Thompson's Station Greenway – Ph 3

Bid Addendum #1

Issued 8/14/2024

Items 1-2 Plan/Bid Quantity Revisions

Item #1

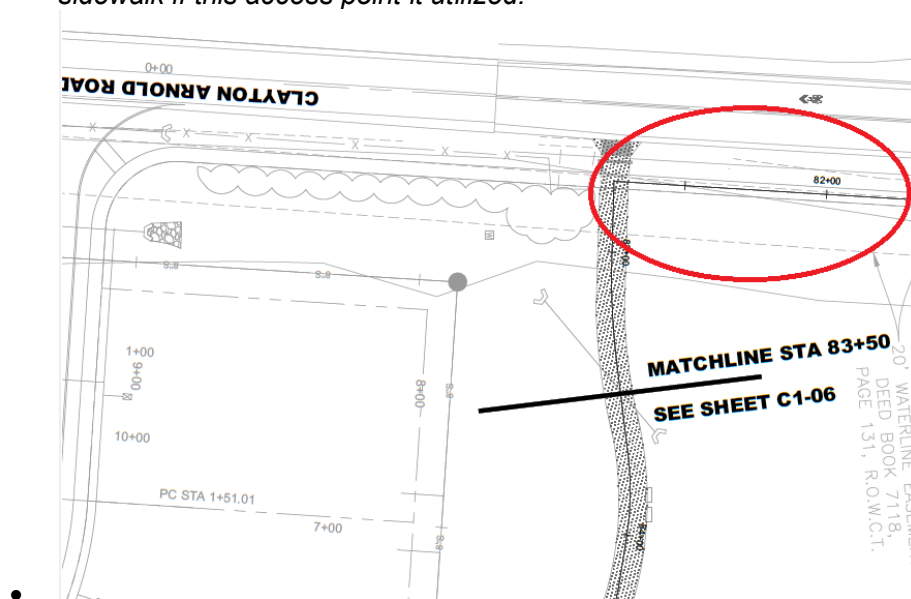
There is no pay item for Placing and Spreading Topsoil. Will you add the TDOT pay item 203-04 Placing and Spreading Topsoil?

- *The respreading of topsoil shall be factored into item 203-01. 203-07 shall only be used for topsoil brought in from off site.*
